Access Compliance Report

(Curb Ramps)

Intersection ID: 31585	Main Street: NAPTON_CT	Cross Street: PATTONSBURG_DR	Location: SE
ADA ID: E1B00CB9DDAA	Ramp Type: BlendTrans1	Initial Pass/Fail: Fail	Overall Compliance: No
Severity Score: 10			
Codes/Mitigation Info/Possible Solution		Field Measurements/Component Compliance

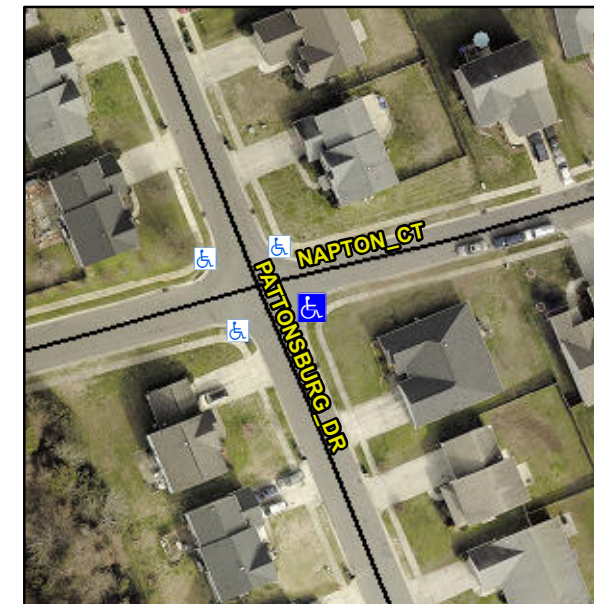
Not Found, R304.5.1, R304.5.3

Compliance	Description	Data	Compliance	Description	Data
N/A	Ramp Length (in)	52.0	Yes	BlendTrans Slope (%)	3.2
No	Ramp Width (in)	40.0	No	BlendTrans XSlope (%)	2.2
N/A	Flare Type LT	N/A	N/A	Flare Type RT	N/A
N/A	Flare Slope LT (%)	N/A	N/A	Flare Slope RT (%)	N/A
N/A	Flare Traversable LT?	N/A	N/A	Flare Traversable RT?	N/A
N/A	Landing Length (in)	N/A	N/A	DWS Provided?	N/A
N/A	Landing Width (in)	N/A	N/A	DWS Contrast?	N/A
N/A	Landing Slope (%)	N/A	N/A	DWS Length (in)	N/A
N/A	Landing X Slope (%)	N/A	N/A	DWS Full Width?	N/A
N/A	Landing Curb? (Y/N)	N/A	N/A	DWS Offset (in)	N/A
N/A	Shared Landing?	N/A			
N/A	Gutter Ponding?	N/A	N/A	Gutter Slope (%)	N/A
N/A	Gutter Lip Ht (in)	0.5	N/A	Gutter X Slope (%)	N/A
N/A	Painted X Walk1?	No	N/A	Painted X Walk2?	No
	X Walk 1 Direction	To N		X Walk 2 Direction	To W
	X Walk 1 Width (in)	N/A		X Walk 2 Width (in)	N/A
	X Walk 1 Slope (%)	3.3		X Walk 2 Slope (%)	0.8
	X Walk 1 X Slope (%)	0.7		X Walk 2 X Slope (%)	3.0

N/A	Ramp inside XWalk1?	N/A	N/A	Ramp inside XWalk2?	N/A
	Road Slope (%)	1.4		Clear Space?	N/A
	Road X Slope (%)	2.6	N/A	Clear Space to XWalk (in)	N/A
N/A	Any Obstructions?	N/A	N/A	Storm Grate/Utility Hazard?	N/A
	Obstruction Type			Storm Grate/Utility Type	
		N/A			N/A
			Yes	Surface Condition? (G/P)	Good
			No	Curb Slope (%)	15.8

Remove & Replace Curb Ramp With Two New Directional Ramps or Equivalent.
